Tule Lake Subbasin

Groundwater Sustainability Plan

Periodic Evaluation

DRAFT

Figure 6-1. Representative Monitoring Well Network

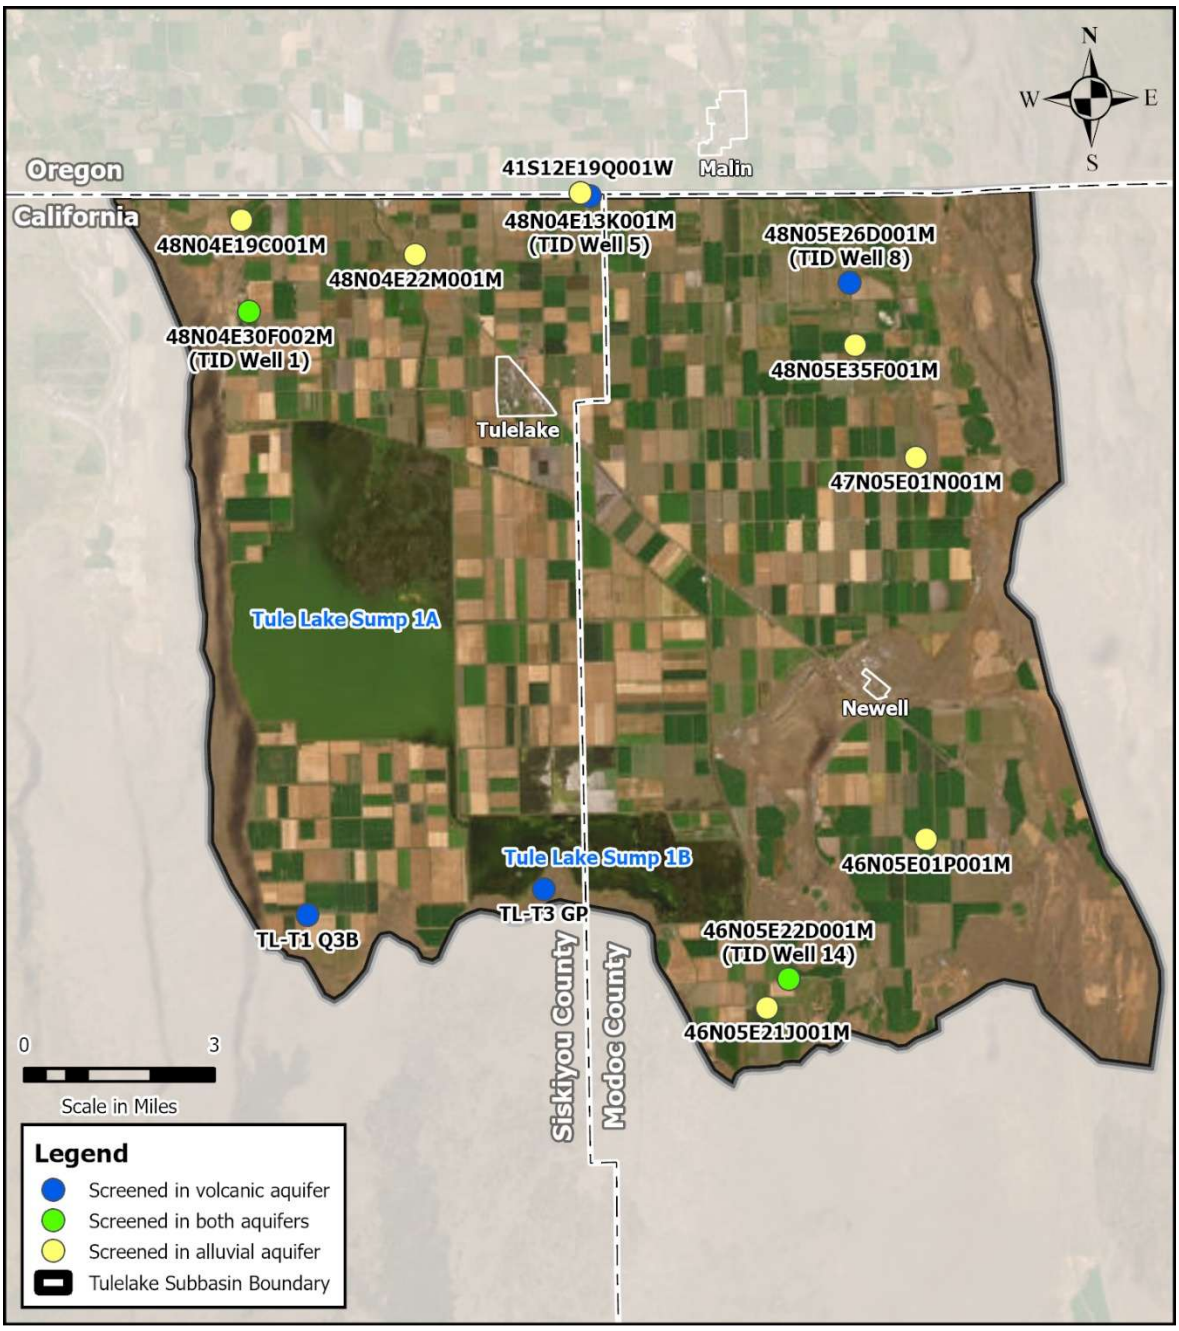
> *"Identify the screen and completion depths, and the associated principal aquifers, of representative monitoring sites for degraded water quality. Describe how potential data gaps in the degraded water quality monitoring network will be filled to sufficiently monitor impacts to beneficial uses or users of groundwater."*

In response to Recommended Corrective Action 8a the GSAs have updated the following table to include the aquifer for the screened depths at each of the representative monitoring wells. A figure with the representative monitoring well and associated aquifer has also been provided.
